**APPLICATION FOR PERMISSION
UNDER SECTION 16 OF
THE TOWN PLANNING ORDINANCE
(CAP.131)**

For Official Use Only 請勿填寫此欄	Application No. 申請編號	A/YL-ST / 653
	Date Received 收到日期	7 JUN 2023

Geotechnical Planning Review Report for Installation of Proposed Public Utility Installation and Associated Filling and Excavation of Land (OHL Pole & Stay Erection)

Proposed Public Utility Installation (Pole and Pole Stay Erection) and Associated Filling and Excavation of Land in “Conservation Area” and “Green Belt” Zones, Government Land in D.D. 96, Lok Ma Chau, San Tin, Yuen Long		
Environmental Protection Departmental Comments	Responses	
The applicant should provide further information to address potential water quality impacts:	the following measures will be carried out during construction and operation stages to address potential water quality impact:	
The mitigation measures to be implemented during construction phase to handle non-point source and point source pollution, such as runoff and sewage from construction site workers, etc	In the construction phase, to minimize the potential water quality impacts while excavation work, the extracted sediment would place in a bag and transported to

Vehicular Road Access Plan

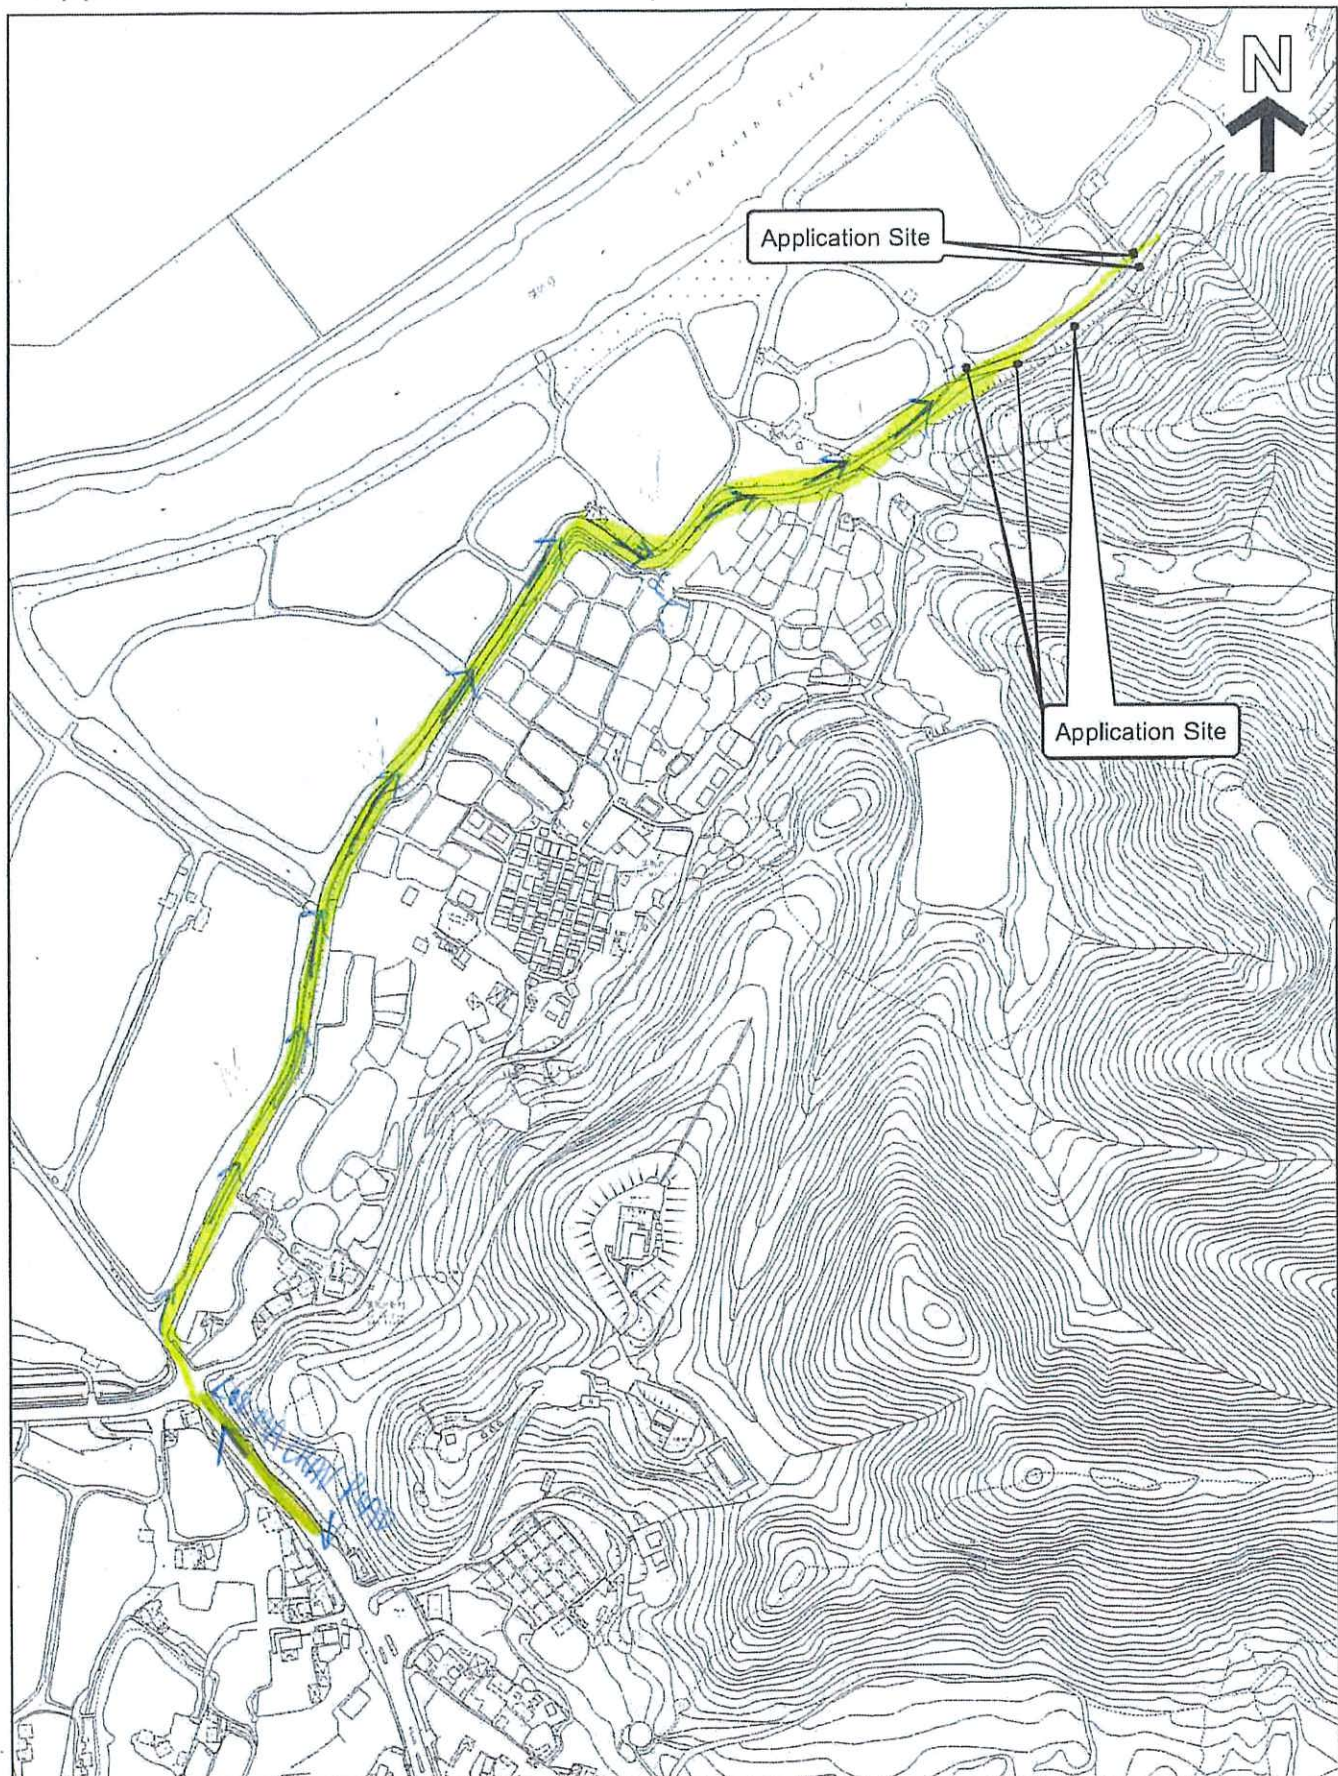
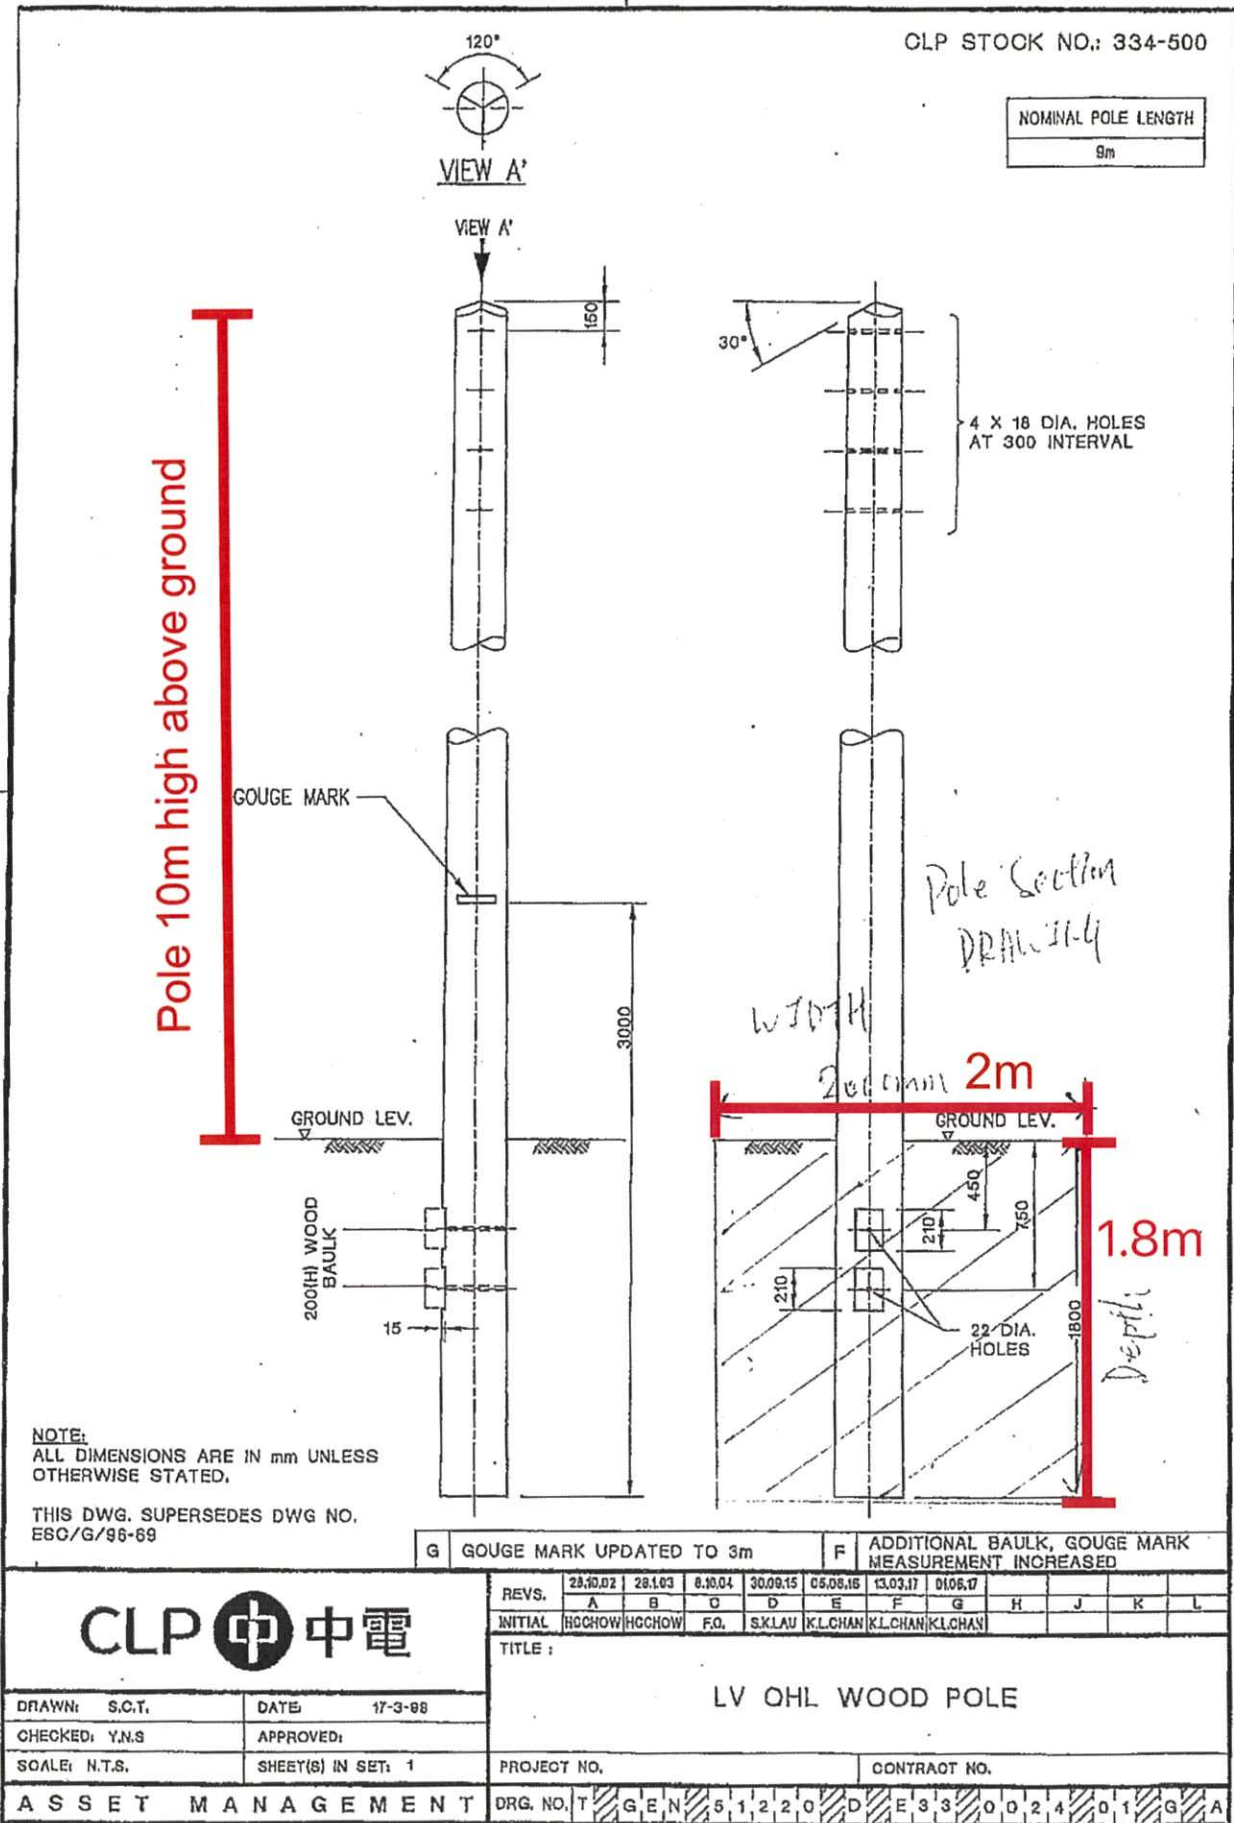
(b) The applicant should provide details of trip generation during the construction period of pole and pole stay erection.

(c) Please provide details of the loading/unloading area in the application."

(b) The applicant should provide details of trip generation during the construction period of pole and pole stay erection.	For the installation for 5 poles, it takes a round trip per location, the total trip would be around 10 trips for the work.
(c) Please provide details of the loading/unloading area in the application.	After prepared the pole hole the pole would install in the pole hole than the unloading area of other material would be around 2 metres by 2 metres.
